WILLIAMSON COUNTY, TEXAS

CHANGE ORDER NUMBER: 6

Project: SE LOOP S1 P1

Change Order No. 6

SE LOOP SEGMENT 1 PHASE 1
PAVEMENT MARKING
& DELINEATION PLAN

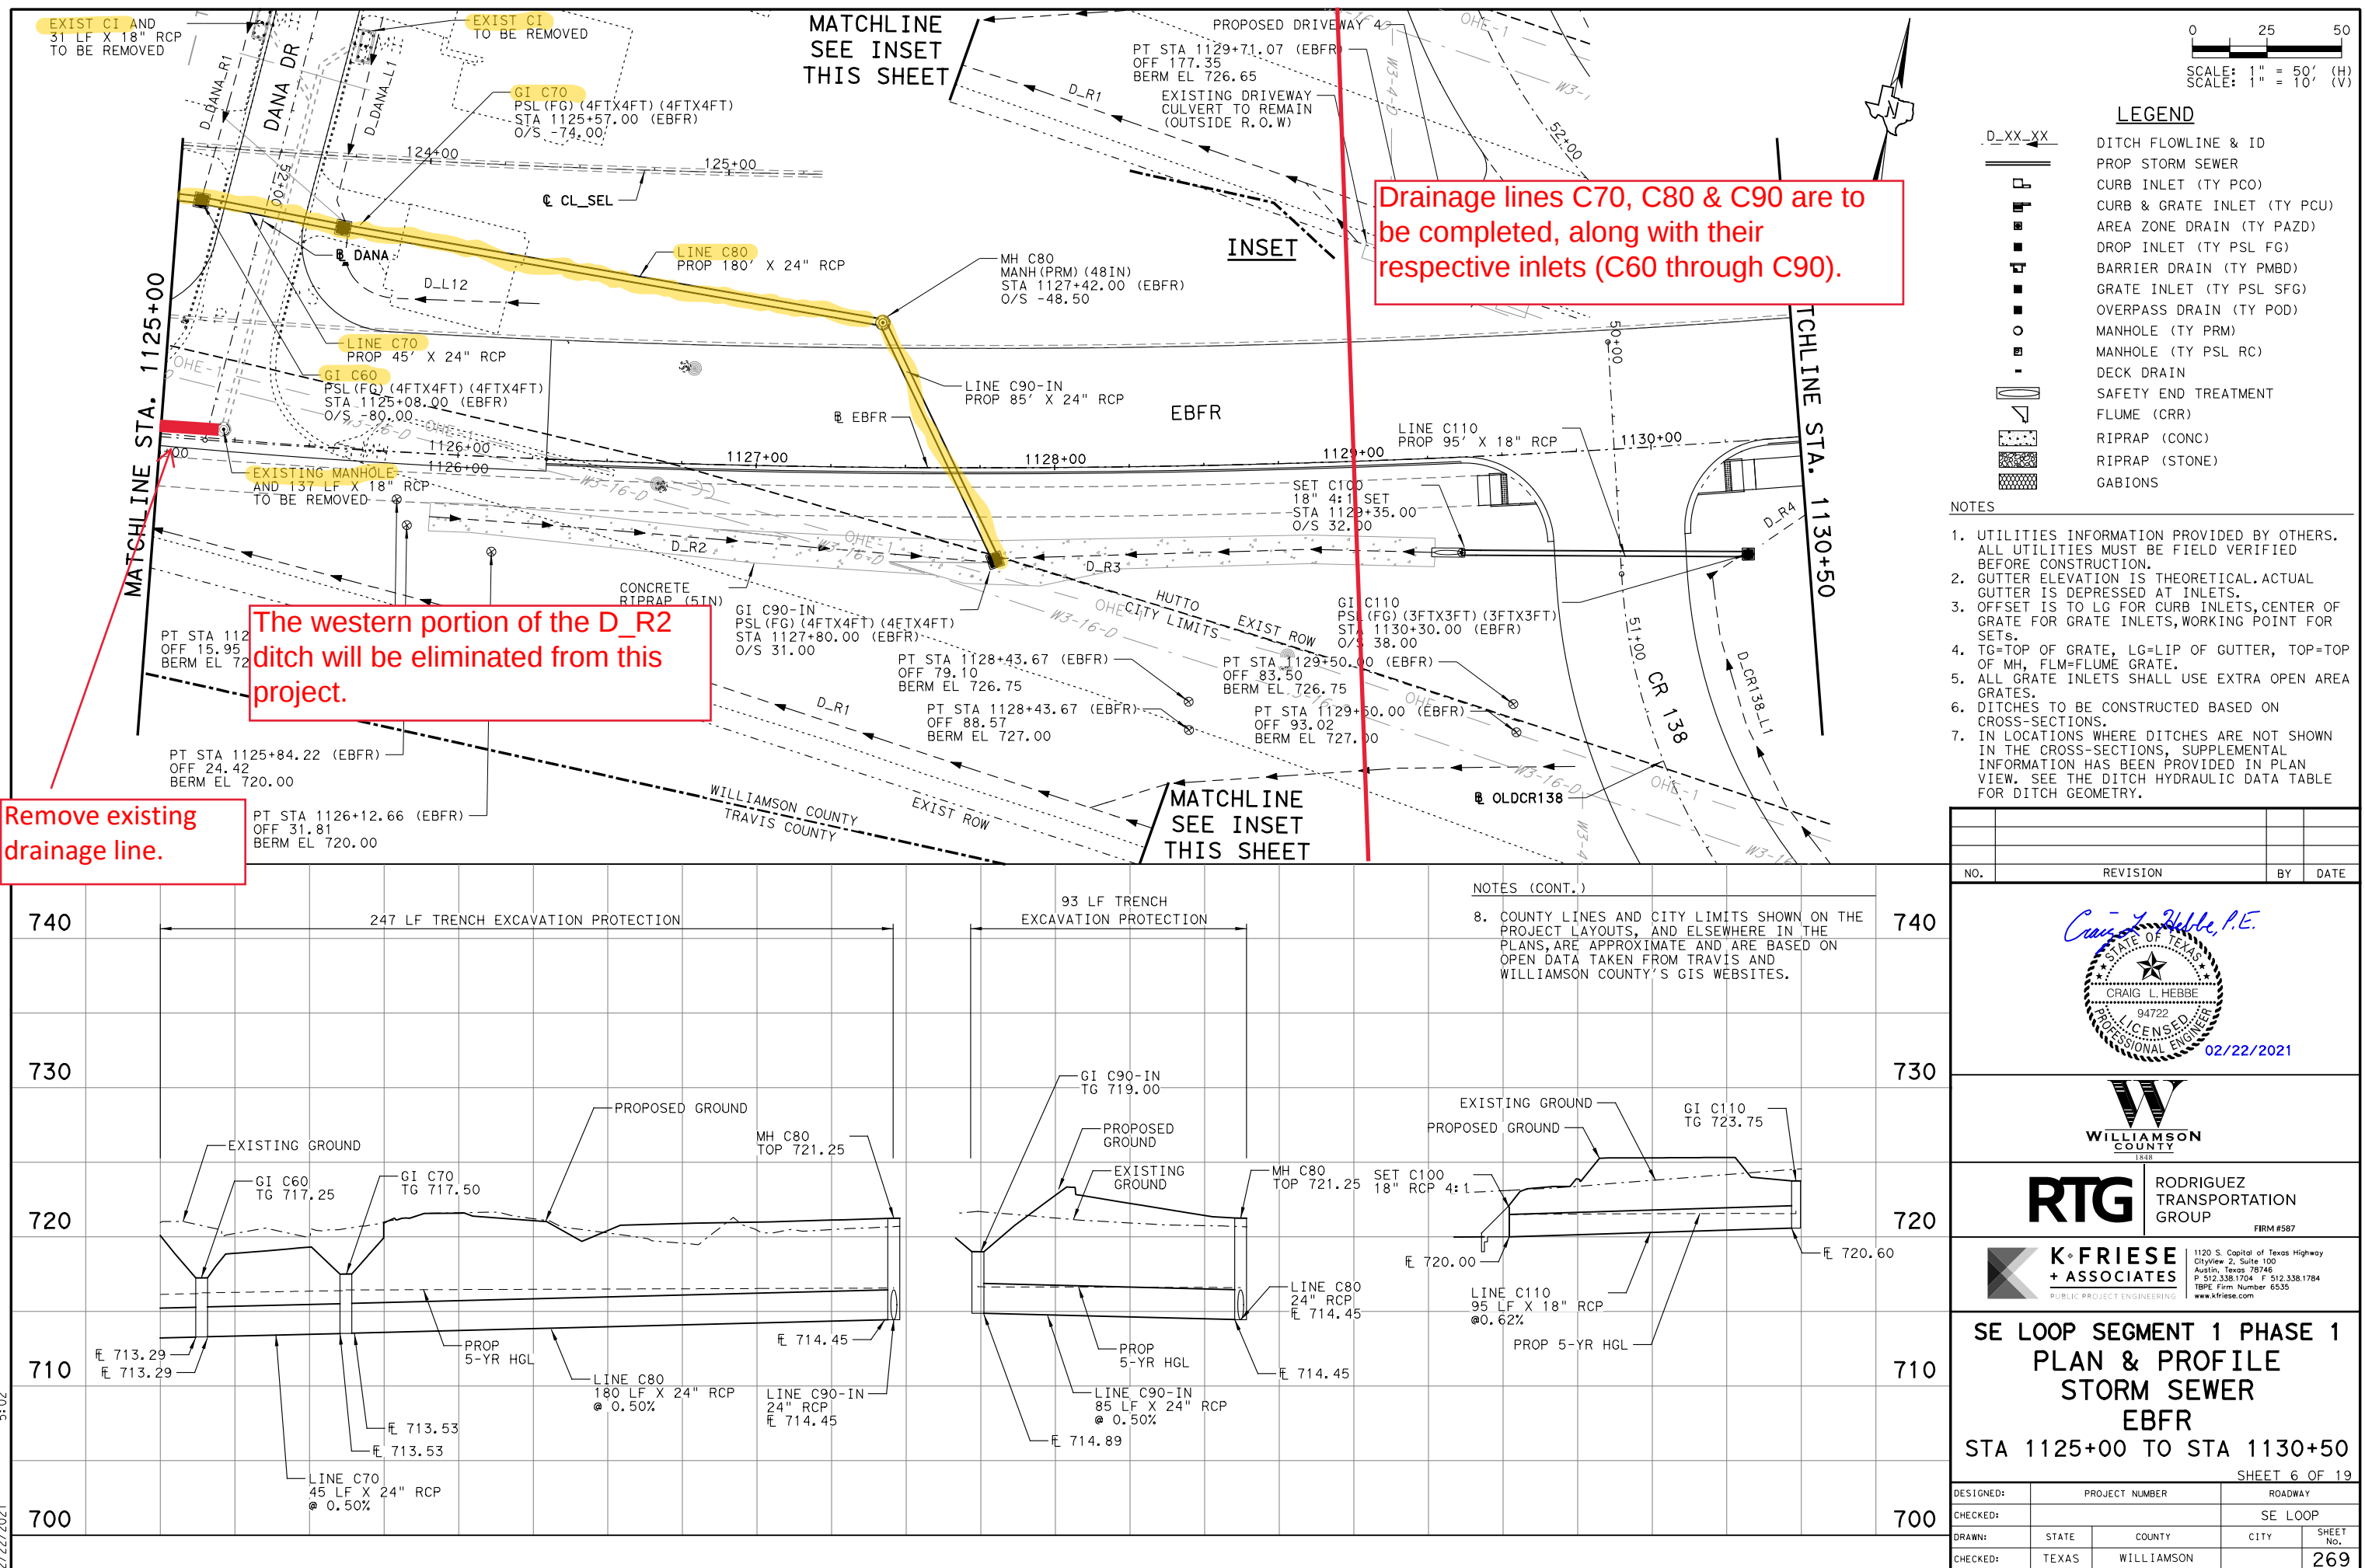
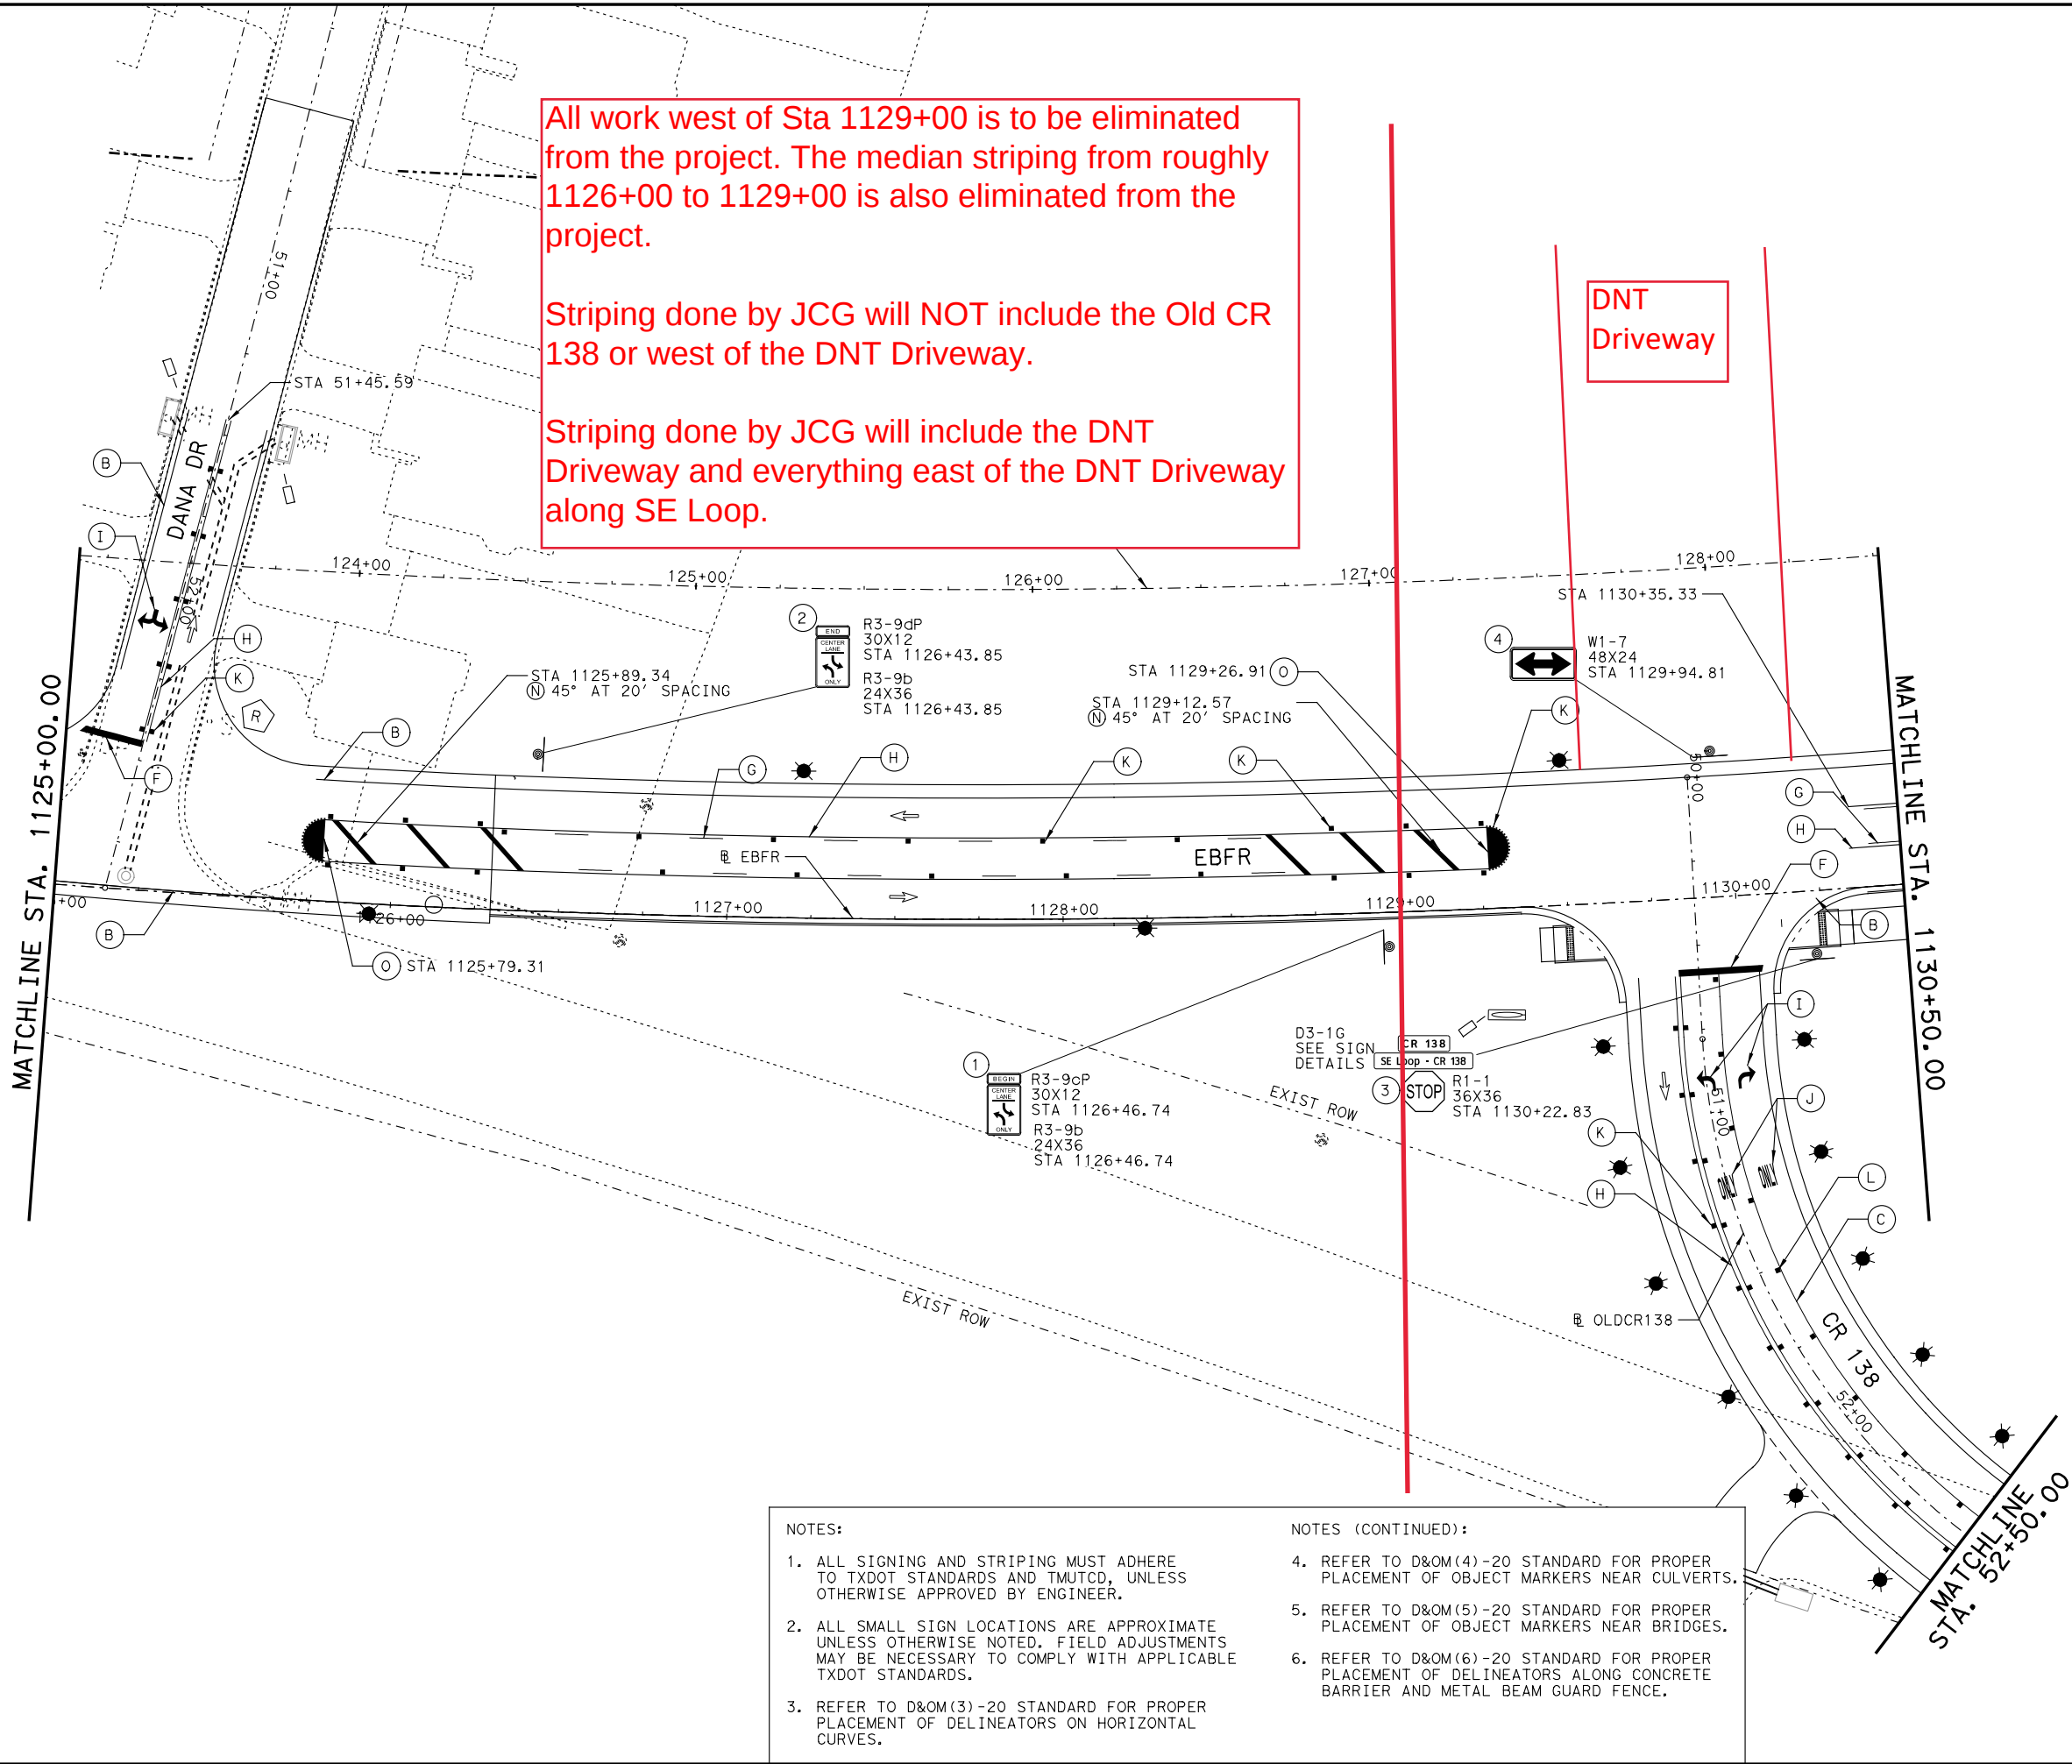
All work west of Sta 1129+00 is to be eliminated from the project. The median striping from roughly 1126+00 to 1129+00 is also eliminated from the project.

Striping done by JCG will NOT include the Old CR 138 or west of the DNT Driveway.

Striping done by JCG will include the DNT Driveway and everything east of the DNT Driveway along SE Loop.
